## ADDENDUM No. 3

### RFP No. 22-76

#### East Medical Center Drive Bridge Rehabilitation and Widening Project

PROJECT MANAGEMENT - PUBLIC SERVICES - CITY OF ANN ARBOR	
<b>EAST MEDICAL CENTER DRIVE</b>	
<b>GENERAL PLAN OF STRUCTURE</b>	
SCALE HOR. 1/4"=1'-0"	INCH 0 1
DRAWING NO. <b>2021-008-BR7</b>	
SHEET NO. <u>70</u> OF <u>153</u>

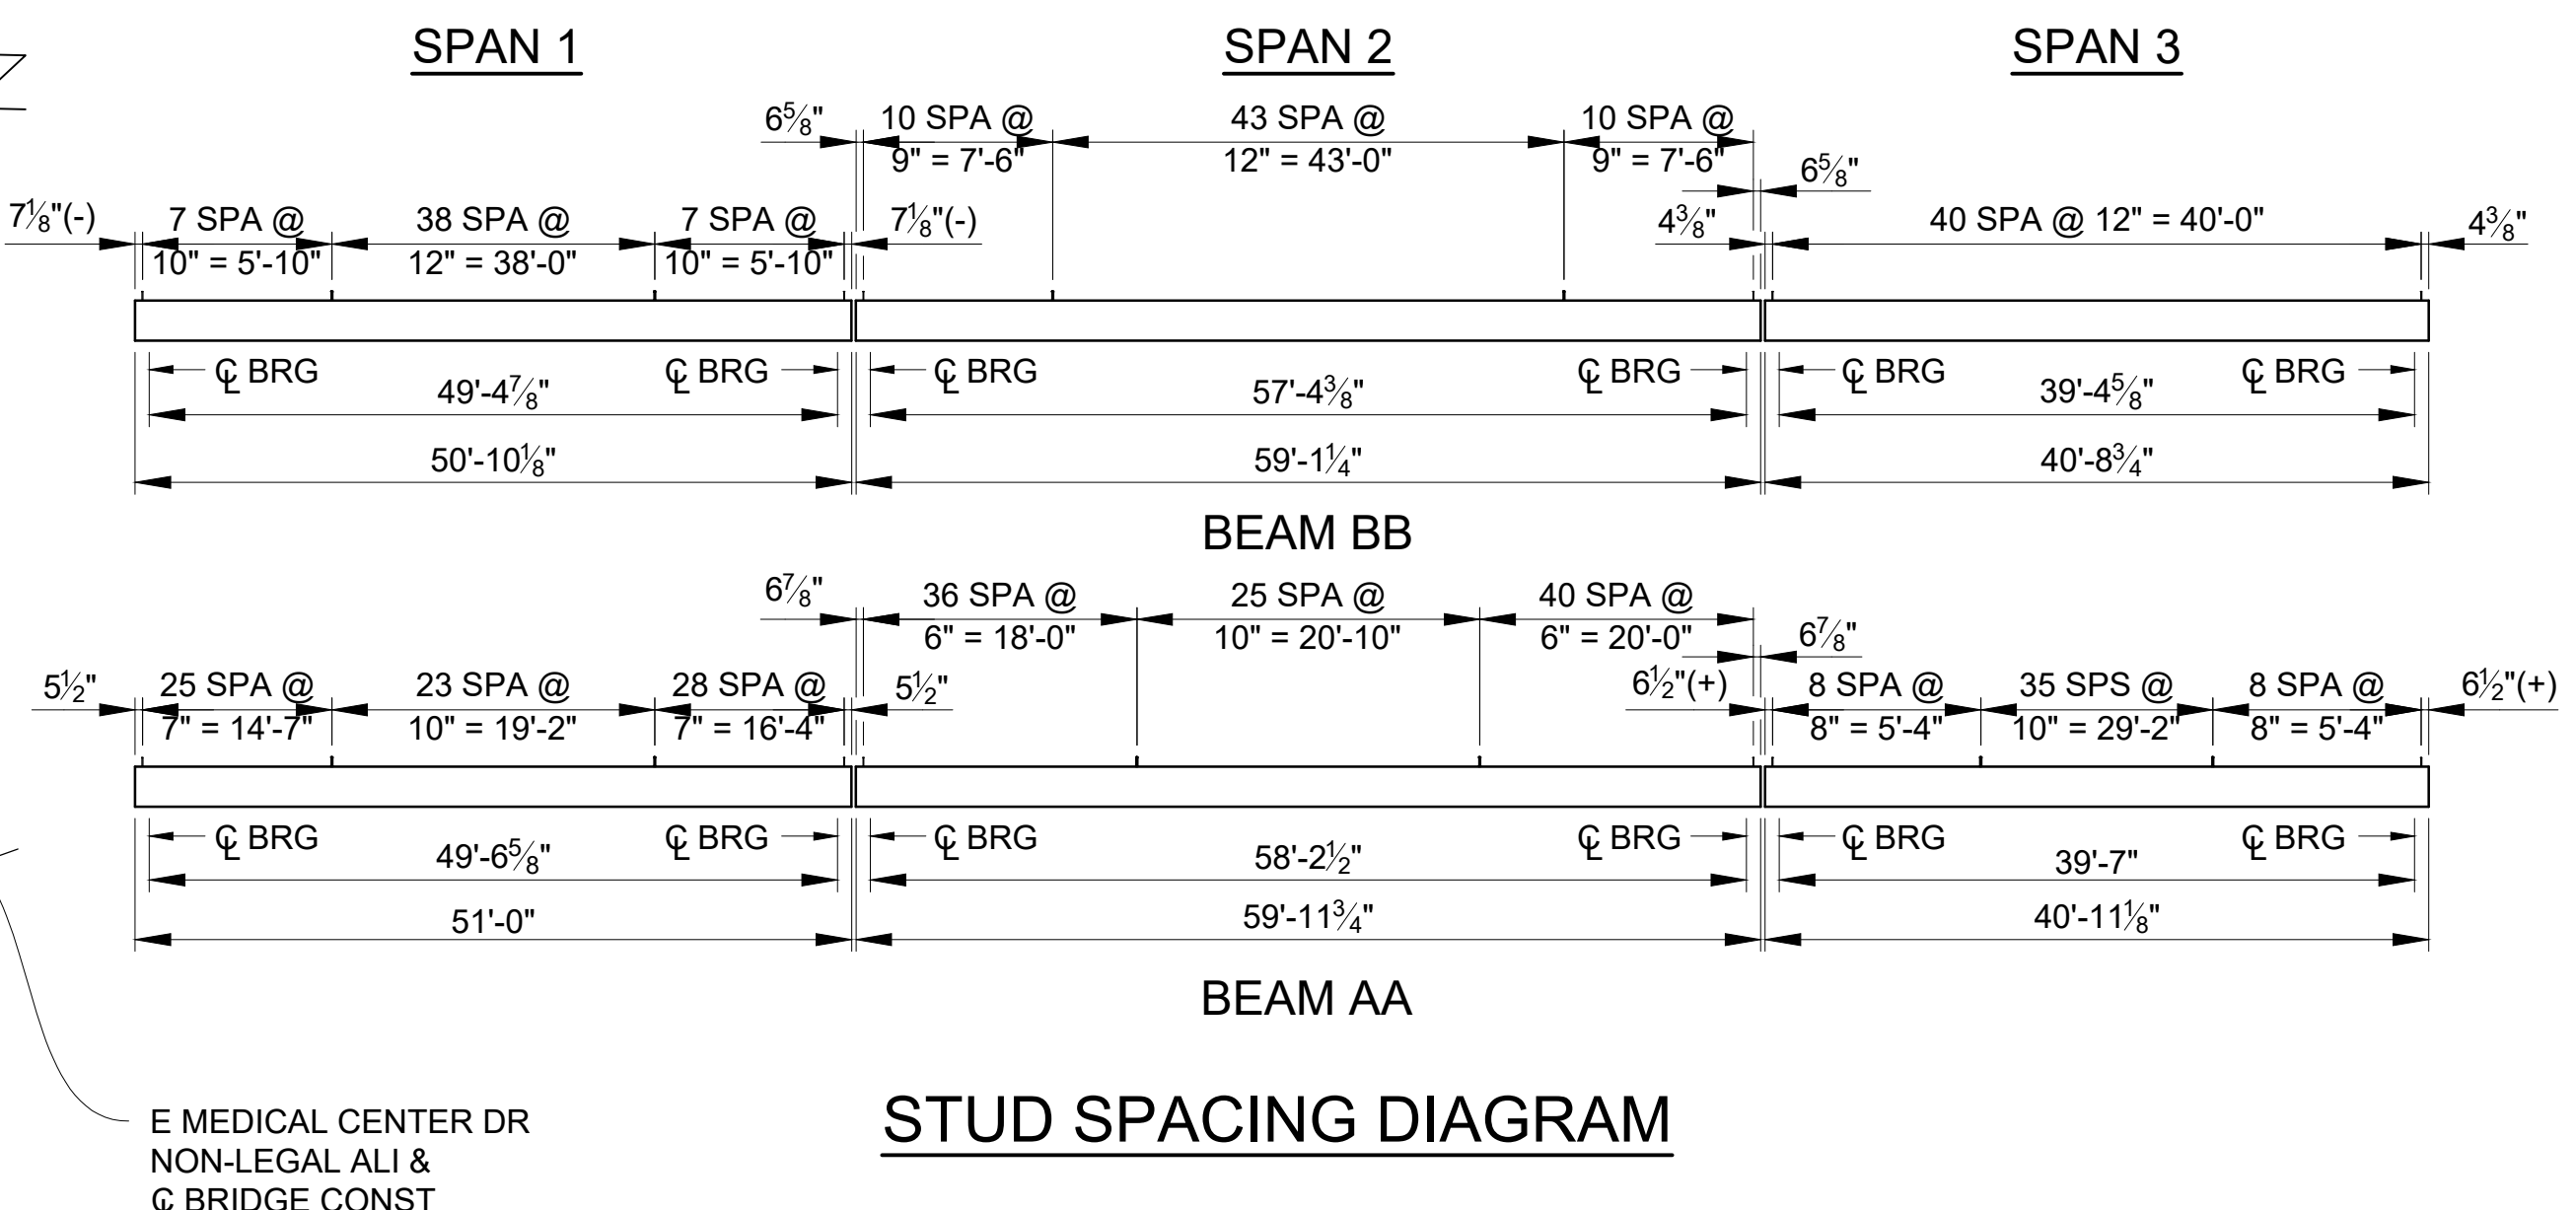
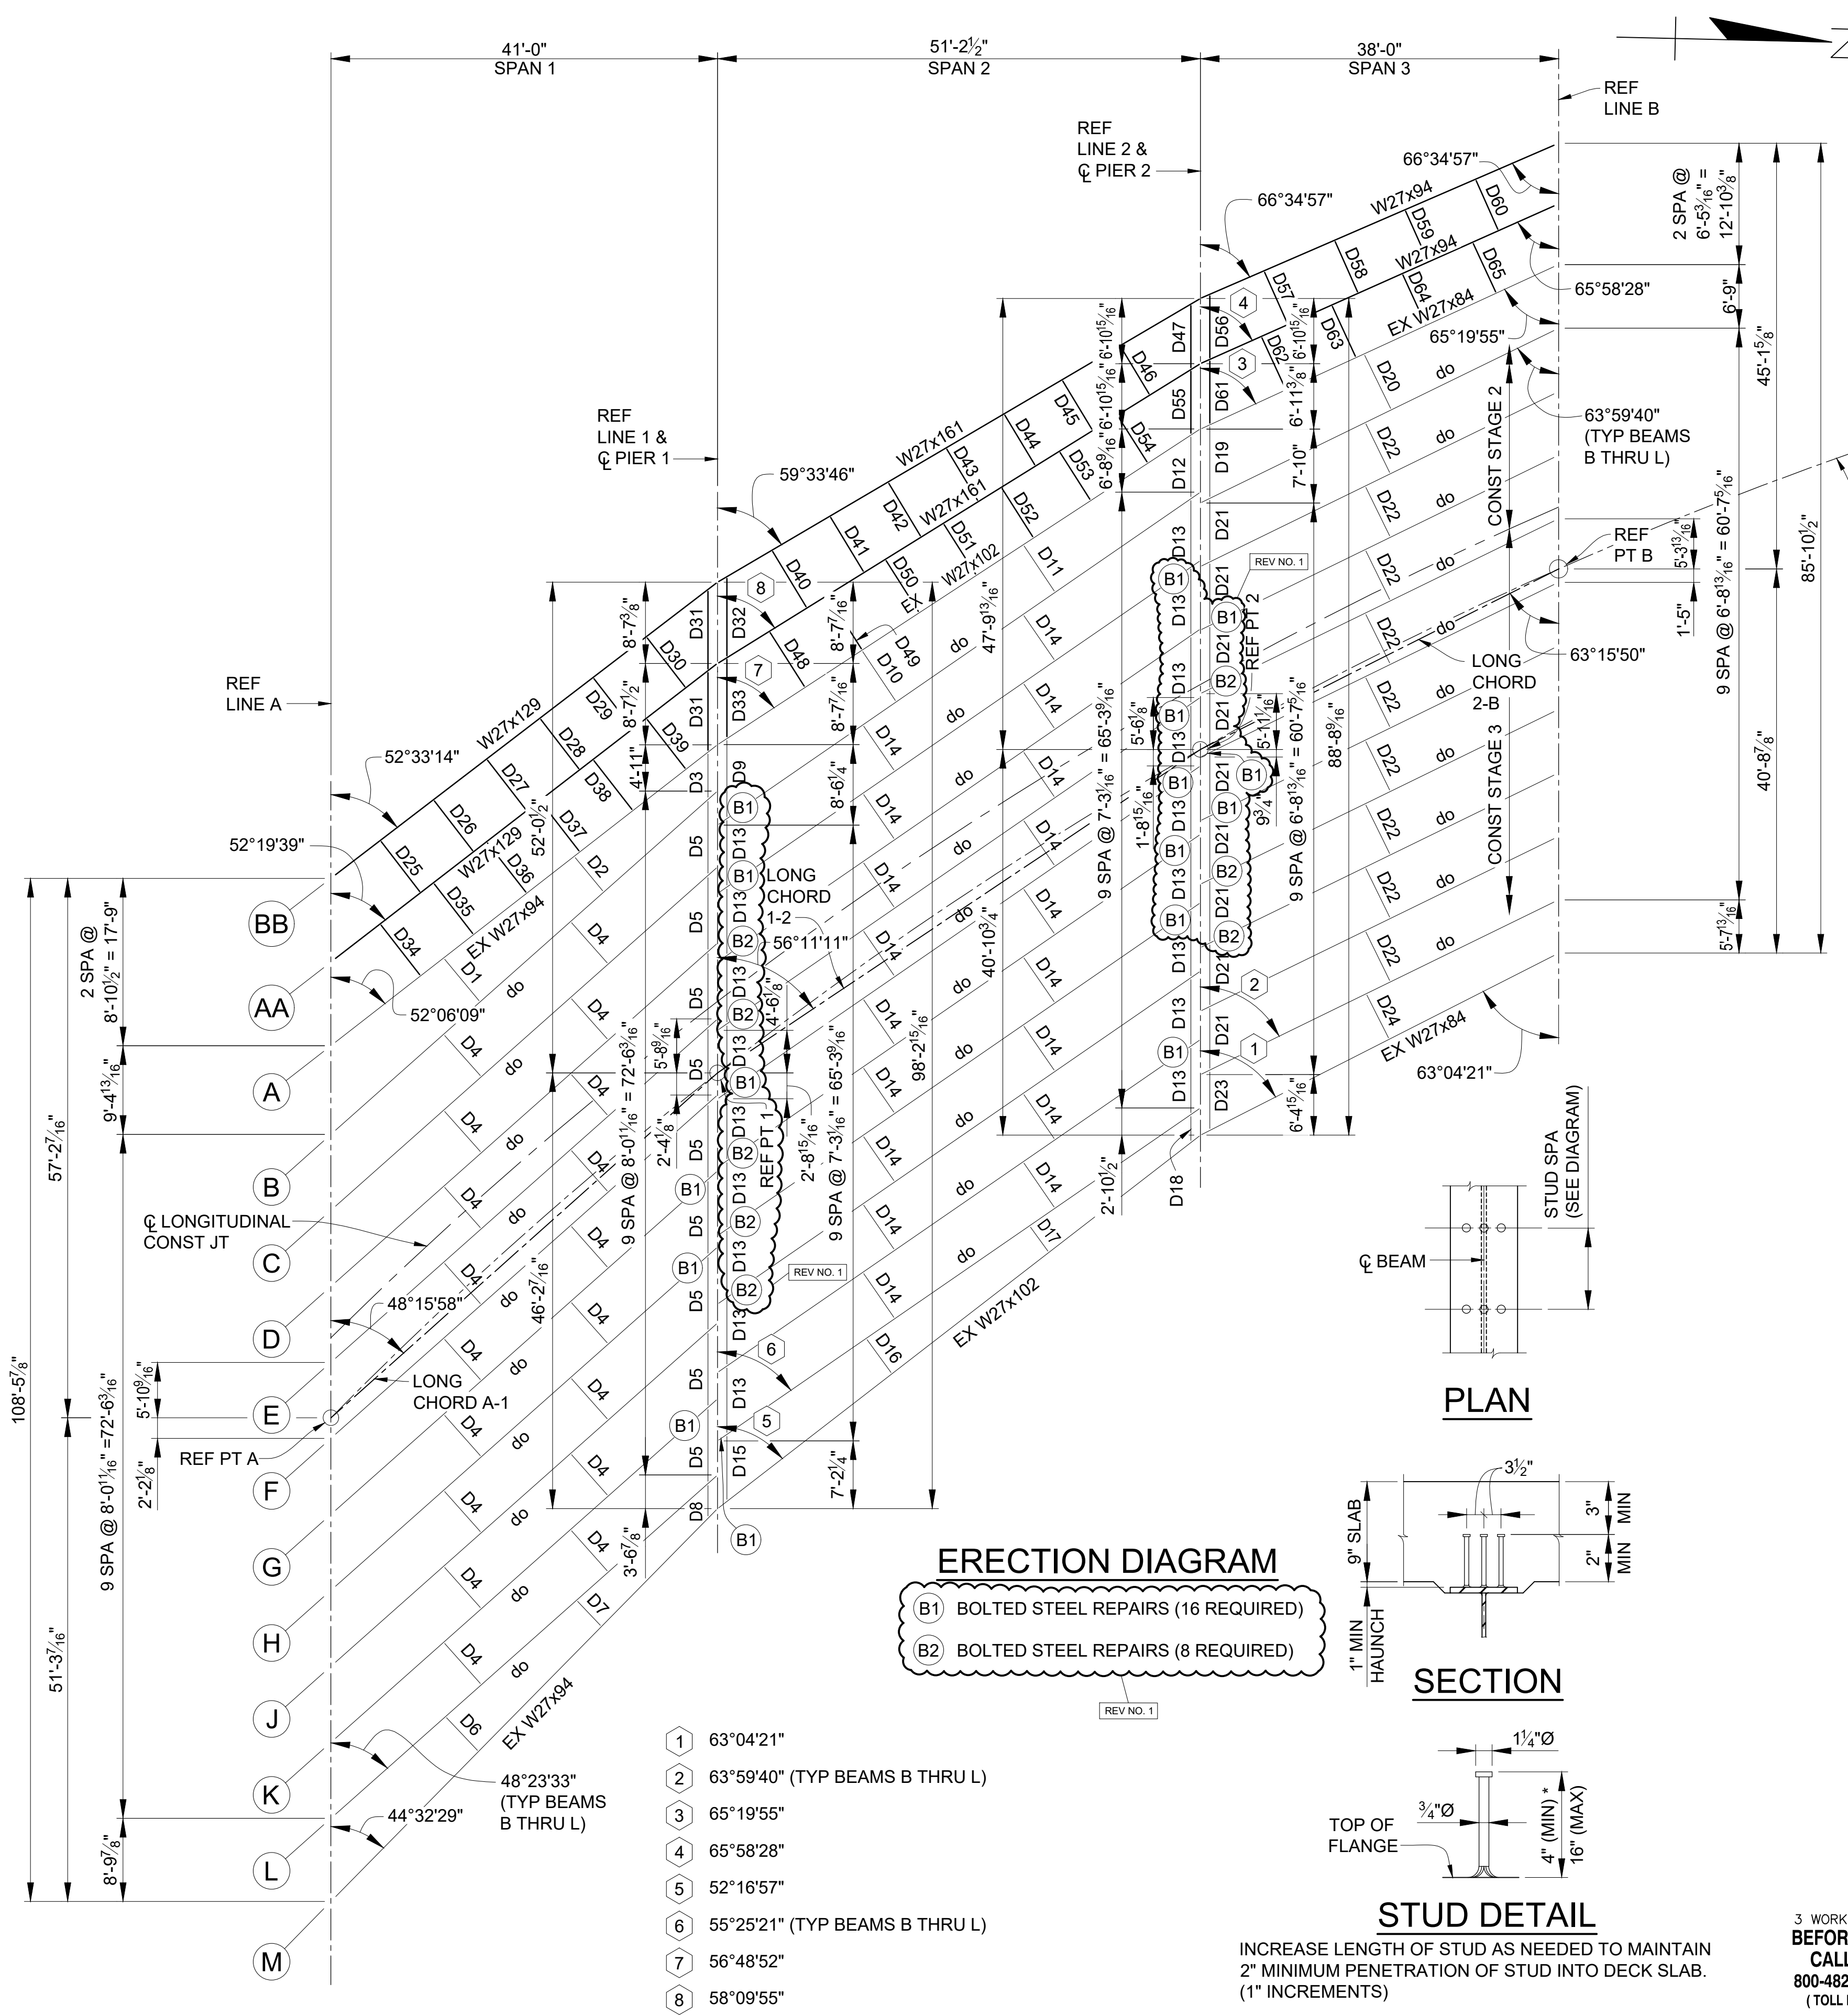
RFP_22-76_Plans Sheet 11	The cross-section was updated to show a proposed chain link fence on top of the barrier.
RFP_22-76_Plans Sheet 12	The cross-sections were updated to show a proposed chain link fence on top of the barrier.
RFP_22-76_Plans Sheet 69	The elevation view was updated to show a proposed chain link fence on top of the barrier.
RFP_22-76_Plans Sheet 70	The cross-section was updated to show a proposed chain link fence on top of the barrier.
RFP_22-76_Plans Sheet 91	<p>Additional bolted steel repairs were added based on the results of the October 2022 bridge inspection.</p> <p>The "Structural Steel, Mixed, Erect" and "Structural Steel, Mixed, Furn and Fab" CATG 0001 quantities have been increased from 32,419 lb to 38,695 lb and the total quantity was increased from 46,581 lb to 52,857 lb.</p> <p>The "Beam Plate, Seal Perimeter" quantity was increased from 1,660 ft to 2,320 ft.</p>
